Federal Energy Regulatory Commission

[Docket Nos. RM12-6-000 and RM12-7-000; Order No. 773]

Revisions to Electric Reliability Organization Definition of Bulk Electric System and Rules of Procedure

ACTION: Final rule.

**Figure 1**  
**Two Radial Systems Eligible for Exclusion E1**

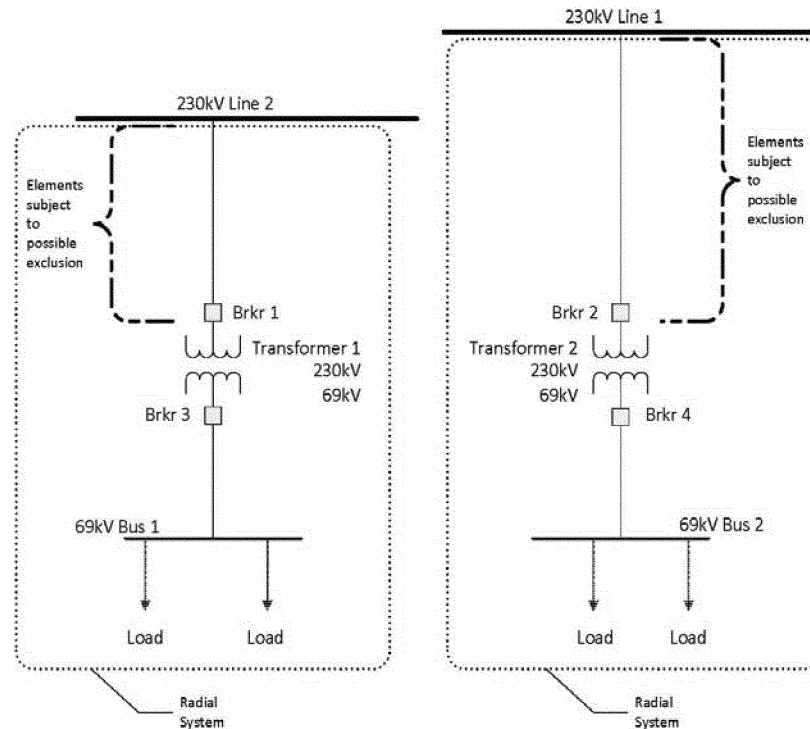
135. NERC and other commenters state that both radial systems depicted in figure 1 would be subject to exclusion E1(a) because they each only serve load.<sup>126</sup> ELCON agrees with NERC adding that these types of radial systems pose no reliability risk to the interconnected transmission network if the system is lost due to a fault condition. Similarly, SoCal Edison states that the figure 1 facilities would either be excluded or not part of the bulk electric system. SoCal Edison asserts that, because transformers 1 and 2 each have secondary voltages that are less than 100 kV, they do not meet the inclusion I1 requirements and, thus, are not included in the bulk electric system. In other words, SoCal Edison believes exclusion E1 should exclude all radial facilities that are greater than 100 kV up to the point where “the system is no longer radial, as indicated in figure 1 by the brackets where the 230 kV lines meet [lines 1 and 2].”<sup>127</sup> APPA believes that all the scenarios described by the Commission could create reliability concerns “if taken in isolation and operated in a certain matter” and

136. Anaheim agrees that the radials shown in figure 1 should be excluded and requests clarification that the associated bus work and protection system equipment installed on those radial lines are also excluded. Anaheim advocates that the exclusion should also apply to protection system equipment on the excluded facilities that provide backup protection for devices that are part of the bulk electric system, i.e. lines 1 and 2 in figure 1.

140. The Commission agrees with NERC that the radial systems shown in figure 1 meet the definition of “radial system” in exclusion E1. This configuration would result in the 230 kV lines between transformers 1 and 2 to the two 230 kV lines, respectfully, being excluded from the bulk electric system. The Commission agrees with NERC and other commenters that both radial systems depicted in figure 1 would be subject to exclusion E1 condition (a) because they each only serve load.

**Figure 2**  
**Networked Configuration w/115 kV Loop**

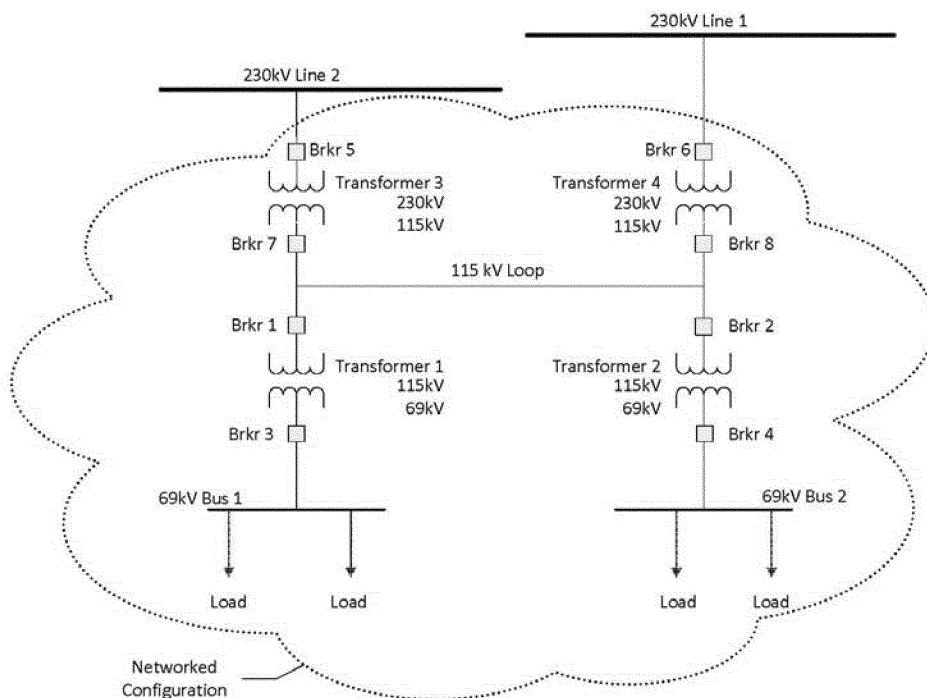
144. In the NOPR, the Commission requested comment on the scenario shown in figure 2 which shows a 115 kV loop, with the configuration emanating from two points of connection of 100 kV or higher. Specifically, the Commission requested comment on whether “the 115 kV and 230 kV elements above Transformers 1 and 2 to the points of connection to the two 230 kV lines would be excluded from the bulk electric system pursuant to exclusion E1.”<sup>130</sup> The Commission asked for comment on whether it is more appropriate to analyze figure 2 pursuant to the “local network” exclusion E3 and, if so, what if any elements operated at or above 100 kV would be excluded pursuant to exclusion E3.

145. NERC states that figure 2 is a non-radial loop on the 115 kV system. According to NERC, the 115 kV elements above transformers 1 and 2 to the point of interconnection with lines 1 and 2 would not be eligible for exclusion E1 because they do not emanate from a single point of connection. NERC also states that it would be appropriate to evaluate figure 2 under exclusion E3 as a potential local network.<sup>131</sup> For such a candidate local network to qualify for exclusion, NERC states that additional technical analysis is needed to determine if all the exclusion E3 criteria are satisfied.<sup>132</sup> NERC asserts that without such a technical analysis, the 115 kV elements above transformers 1 and 2 should be considered part of the bulk electric system.

146. Likewise, Idaho Power, ITC Companies, and National Grid contend that the figure 2 configuration should be included in the bulk electric system. Southern Companies believe exclusion E1 may apply from the breakers down and that the configuration may belong to

exclusion E3. AEP assumes that each of the facilities below the 115 kV loop shown in figure 2, and including breaker 1 and breaker 2, are radial and excluded pursuant to exclusion E1. According to AEP, the facilities above breakers 1 and 2 may be excluded pursuant to exclusion E3 depending on the circumstances.<sup>133</sup>

147. Valero states that the figure 2 configuration is very similar to common facilities configurations employed in many industrial facilities involving the interconnection of the industrial facility to the utility through two high voltage feeder lines that originate at different utility owned and operated substations. Valero requests that the Commission include in the final rule an additional exclusion that would “categorically exclude from the [bulk electric system] any on-site high voltage switchyard facilities (less than 300 kV) owned by the industrial end-user where the predominant function of the facilities is to distribute electricity in an inward direction to the end-user’s load.”<sup>134</sup> WPPC argues that figure 2 shows both radial and network systems and that the system from the 115 kV loop upwards would be assessed under exclusion E3

148. The Commission affirms NERC’s statement that figure 2 is a non-radial loop and thus would not be eligible for exclusion E1 because it does not emanate from a single point of connection. The Commission agrees with commenters that the elements below the 115 kV loop should be assessed as two separate radial systems pursuant to exclusion E1. The remaining elements (the 115 kV loop, transformers 3 and 4 and the 230 kV tie lines above the transformers to the two 230 lines 1 and 2) should be assessed pursuant to exclusion E3 and if the configuration meets the criteria of exclusion E3, the elements could be excluded.

**Figure 3**  
**Networked Configuration w/69 kV Loop**

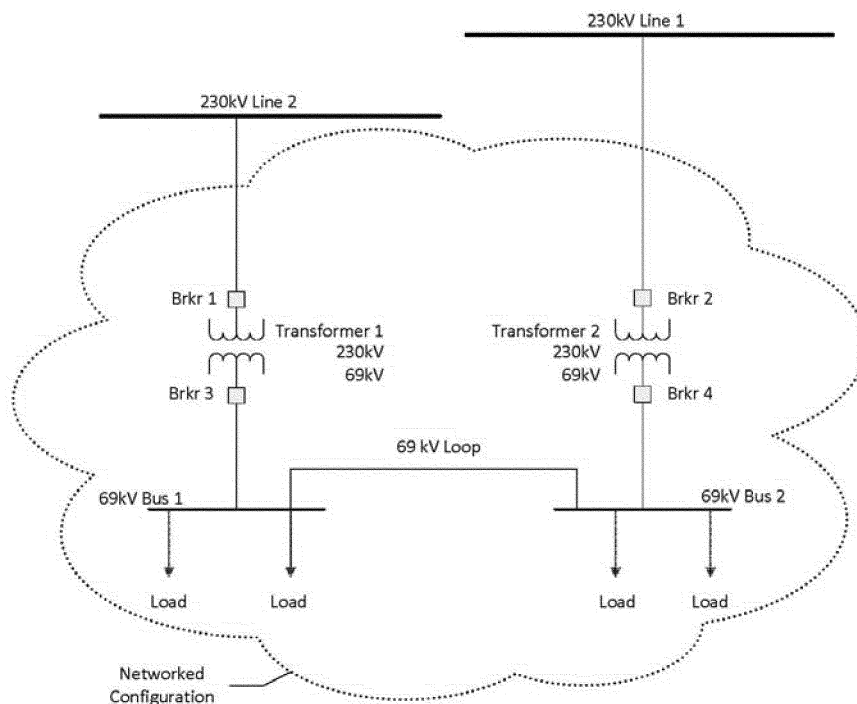
151. NERC disagrees with the Commission's characterization of figure 3 in the NOPR. NERC states that figure 3 does not depict a configuration with two points of 100 kV or higher or a system emanating from two points of connection at 230 kV. According to NERC, except for lines 1 and 2, all the other elements depicted in figure 3 are excluded from the bulk electric system. NERC explains that the elements between line 1 and transformer 2 and from line 2 to transformer 1 are excluded by exclusion E1(a) because "each separate set of [e]lements [described above] is contiguous and emanate from a single point of connection of 100 kV or higher."<sup>137</sup>

153. Exelon agrees with NERC and explains that it has many connections similar to the one shown in figure 3 and provides a specific example where a 138 kV substation is fed by two radially connected 138 kV lines which in turn are connected through 40 MVA transformers to a 12 kV bus section. Exelon states that in its example the 40 MVA transformers cross bus sections so that if one of the 138 kV lines is out of service, each side of the 12 kV bus retains service. Exelon believes that due to the high impedance of the transformers, little energy flows between the buses in Exelon's

154. Other commenters believe that the figure 3 configuration may not be eligible for exclusion E1. SoCal Edison explains that the 69 kV loop is not open and therefore is a parallel path to the 230 kV system. BPA, Alameda and WREA do not view the figure 3 system as eligible for exclusion E1 because the system is networked. Idaho Power states that the 230 kV lines would be included only if there is a protection system in place for the 230 kV lines. According to Idaho Power, the elements above the transformers in figure 3 would not be excluded from the bulk electric system. Idaho Power believes this configuration should be evaluated under exclusion E3.

155. The Commission finds figure 3, which is identical to figure 5, is a networked configuration through a 69 kV loop and does not qualify for exclusion E1. The Commission also finds that, because the load in figure 3 can be served by either 230 kV line, it does not depict a “radial system.” However, the facilities below 100 kV may or may not be necessary for the operation of the interconnected transmission network, and this decision can be made case-by-case in the exception process. In other words, such facilities below 100 kV depicted in figure 3 would be excluded under the general threshold of the core definition unless found on a case-specific basis as necessary for the reliable operation of the interconnected transmission network. Thus, the Commission, while disagreeing with NERC’s interpretation, does not propose to include the below 100 kV elements in figure 3 in the bulk electric system, unless determined otherwise in the exception process. Further, as we discuss below in connection with exclusion E3 and figure 5, while we find that the configuration shown in figures 3 and 5 would not be eligible for exclusion E1, we believe that such configurations should be eligible for exclusion E3 for local networks. However, exclusion E3 as written requires the candidate local network to be contiguous and above 100 kV, thus, the exclusion E3 language as written does not allow for figures 3 and 5 to be eligible for the local network exclusion

because they are not contiguous *and* include facilities that are not above 100 kV. Therefore, we direct NERC to modify exclusion E3 to remove the 100 kV minimum operating voltage in the local network definition. This modification will enable configurations similar to figures 3 and 5 to be assessed for the local network exclusion. The Commission believes this modification, together with satisfying the criteria outlined in exclusion E3, will appropriately exclude local network configurations that are not necessary to the reliable operation of the interconnected transmission network.<sup>139</sup>

**Figure 5**  
**Networked Configuration w/69 kV Loop**

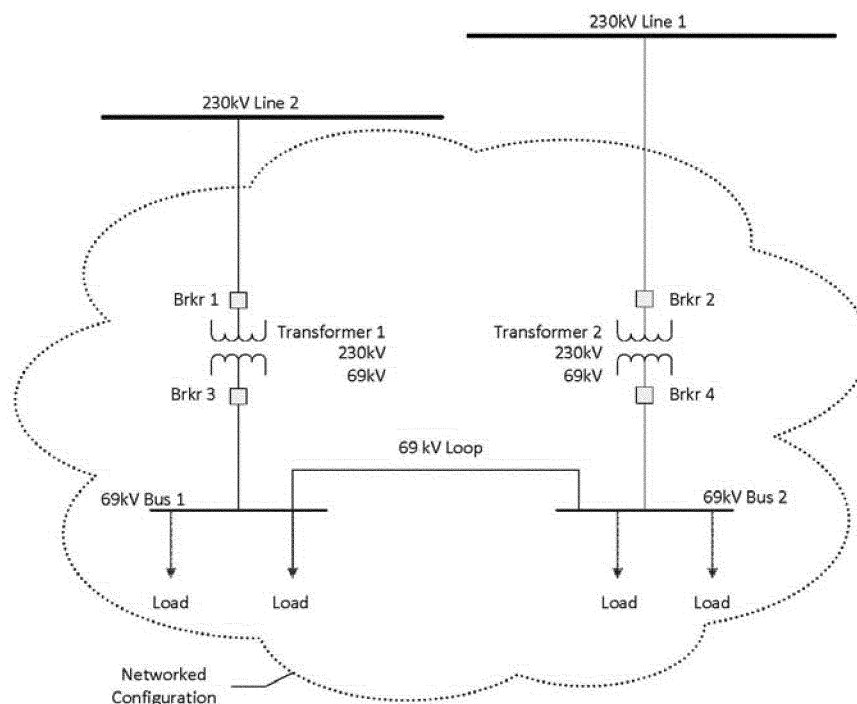
195. In the NOPR, the Commission stated that figure 5 depicts a group of elements that are contiguous through a 69 kV loop and requested comment whether the configuration in figure 5 qualifies as a local network and, in particular, whether the configuration satisfies the conditions that a local network be contiguous and operated at or above 100 kV.

196. NERC views figure 5 the same as figure 3—as a looped system below 100 kV—that is not considered under this exclusion because the elements below 100 kV are presumed to be not part of the bulk electric system.<sup>167</sup> NERC maintains that, if it is determined that the sub-100 kV looped system is necessary for the reliable operation of the interconnected transmission network, the exception process may be utilized to include the appropriate elements. NERC states that figure 5 depicts two separate and distinct groups of elements that each emanate from a

197. Exelon states that the clear intent of the definition is that configurations such as shown in figure 5 are radial systems subject to exclusion E1 (radial systems). According to Exelon, had this not been the intent of exclusion E1, exclusion E3 would have allowed for a local network where the tie was below 100 kV to avoid a reliability gap. Exelon believes that the configuration shown in figure 5, which is identical to figure 3, does not qualify as a local network within the terms of exclusion E3 and supports NERC's view that figure 5 represents two radial systems that qualify under exclusion E1. Exelon cautions that, if the Commission determines that the systems depicted in figure 5 do not qualify under exclusion E1 because of the low voltage tie and does not qualify under exclusion E3 because the tie is at low voltage and not a 100 kV or above, such a decision would leave a gap under which a substantial number of facilities that are not part of the bulk electric system

would be classified as such. Exelon states that it would have to go through the separate exception process for dozens of substations, at great cost and for no useful purpose. Exelon states that the Commission should clarify that the configuration shown in figures 3 and 5 qualifies as a radial system and is excluded pursuant to exclusion E1.

199. As discussed above, the Commission is directing a modification to exclusion E3 to better capture local networks like those depicted in figure 5. The Commission notes that Exelon believes that the configuration shown in figure 5, which is identical to figure 3, does not qualify as a local network within the terms of exclusion E3. While figures 3 and 5 are a networked configuration through a 69 kV loop, they do not qualify for the local network

exclusion because exclusion E3 defines local networks as “[a] group of contiguous transmission Elements operated at or above 100 kV but less than 300 kV that distribute power to Load rather than transfer bulk-power across the interconnected system.” The configuration in figure 5 includes elements that are below 100 kV, and does not have contiguous elements operating at or above 100 kV but less than 300 kV. As noted above, while the Commission finds that these configurations should not be eligible for exclusion E1, we believe that they should be eligible for the local network exclusion. Therefore, we direct NERC to modify exclusion E3 to remove the 100 kV minimum operating voltage in the local network definition. Within 30 days of the effective date of this Final Rule, we direct NERC to submit a schedule outlining how and when it will make the modification to the definition.
